NCC2022 SECTION J PART J4 PERFORMANCE-BASED DESIGN BRIEF (PBDB)

**NOVUS ON VICTORIA, CHATSWOOD
(NON-RESIDENTIAL AREAS)**

Project Number	240482
Project Name	Novus on Victoria, Chatswood
Description	NCC 2022 Section J Part J4 Performance-Based Design Brief (PBDB)
Key Contact	Charles Maxwell - Novus Investco Pty Ltd

DOCUMENT TITLE: Novus on Victoria, Chatswood -
Building Fabric Requirement (non-residential).....

DA 100

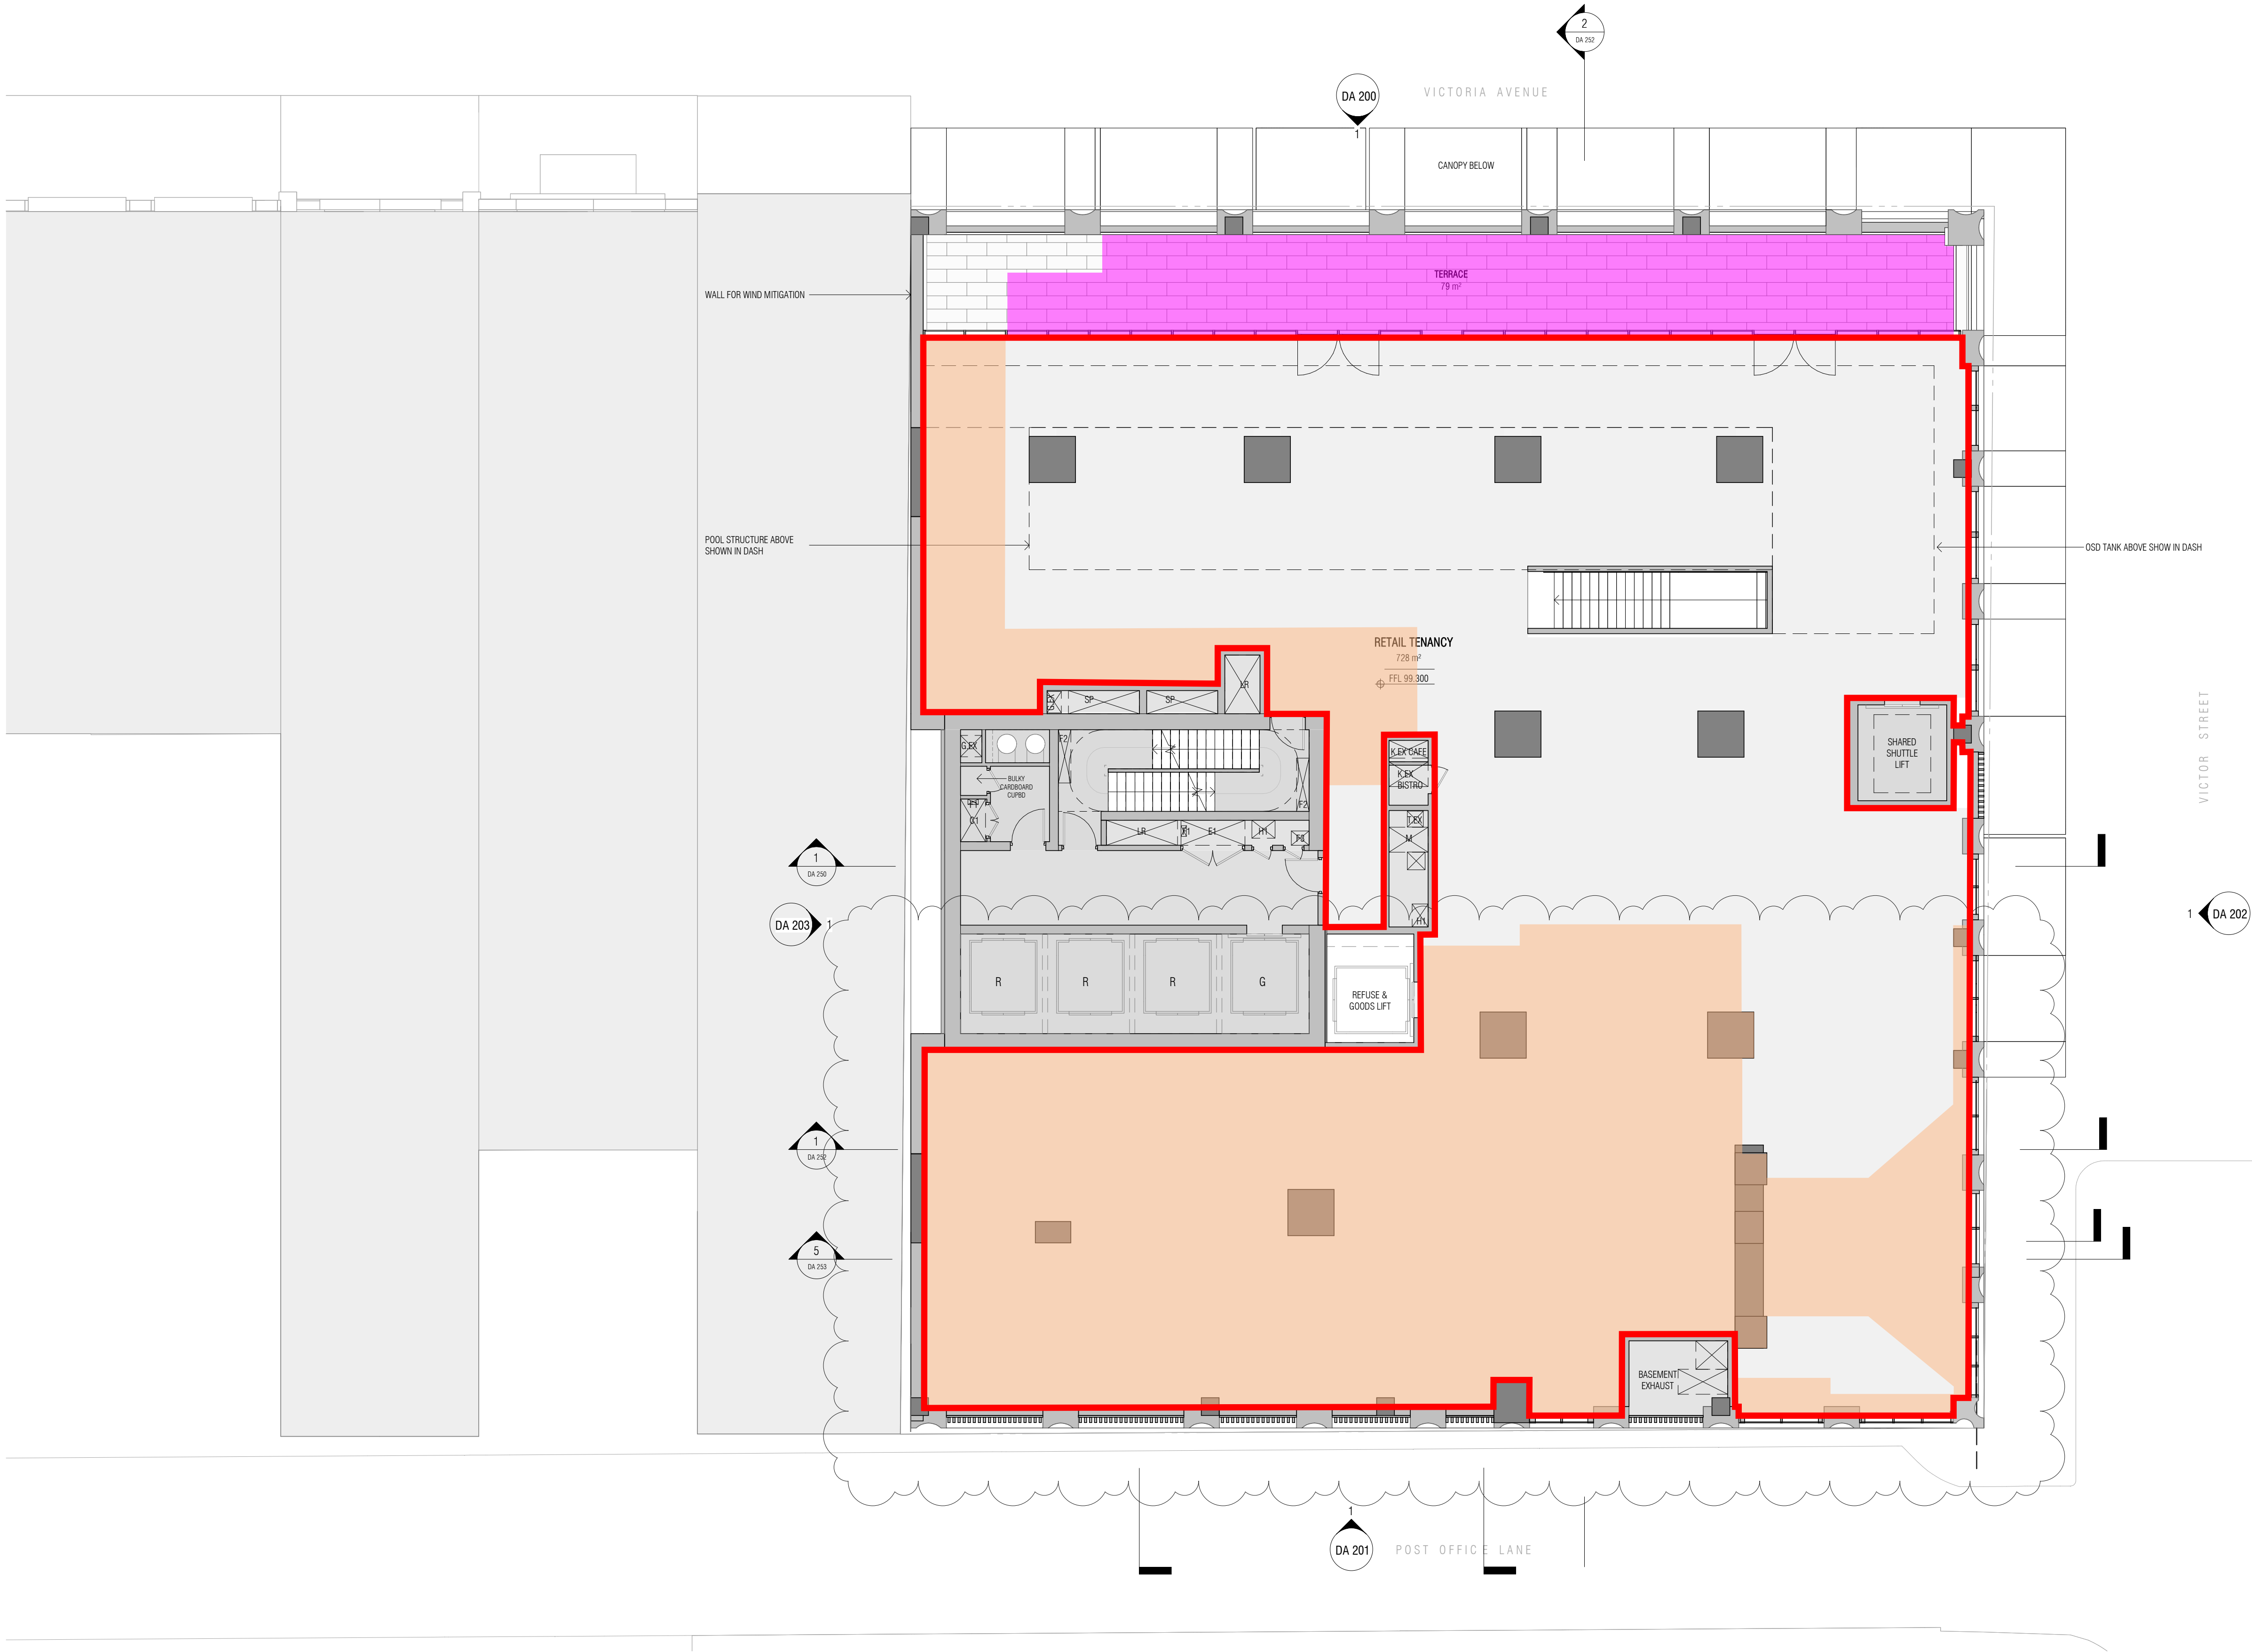
ROOF/CEILING ENVELOPE - TOTAL R3.7
(DOWNWARDS, SOLAR ABSORPTANCE NO MORE THAN 0.45)

ENVELOPE FLOORS (SUSPENDED) -
TOTAL R2.0 (DOWNWARDS)

ENVELOPE WALLS - TOTAL R1.40

Note: The above construction are only to be applied to the **non-glazed portions of the envelope**; glazing must be installed as per the architectural layouts with its thermal performances pursuant to the respective glazing specifications stated in the Section J report (Total Systems U-Value, and Total Systems SHGC value)

*According to clause 2 of Section J4D7, a slab-on-ground that does not have in-slab heating or cooling system is considered to achieve a Total R-Value of R2.0. Hence an additional insulation of R0.2 is only required for Envelope Floors (Slab-on-Ground).
